**TO:** All Bidders  
**FROM:** City of Cambridge  
**DATE:** January 18, 2013  
**RE:** File No. 5994 – Danehy Park Artificial Turf Field Project - Addendum No. 3

**Artificial Turf Field Project, Soccer Fields 1 and 2, Danehy Park, Cambridge, MA**

**ADDENDUM NO. 3**

**CONTRACTOR QUESTIONS AND RESPONSES**

3  
L-5

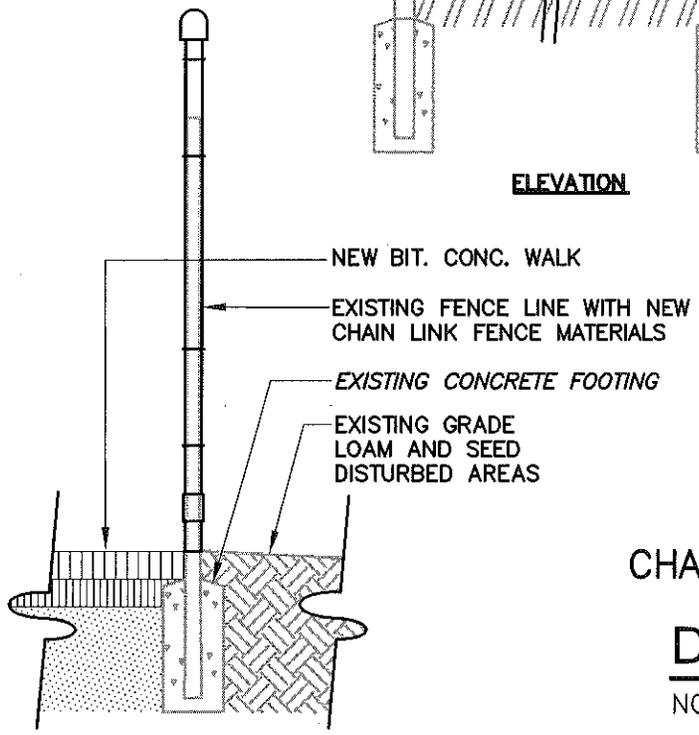
Question #10:	Please confirm the scale for sheet L-2.
Response	1"=20'-0"
Question #11:	Please provide a detail that shows the relationship of the new 4-ft CLF to the edge of the perimeter walkway around.

Response	See updated detail 3/L-5.
Question #12:	Detail 4/L-5 shows the 4-ft tall type 3 fencing for alternate #1. The detail shows a top rail, mid-rail and bottom rail. Please confirm the mid-rail is required.

On sheet L-5, REPLACE Detail 3 with the attached revised detail.
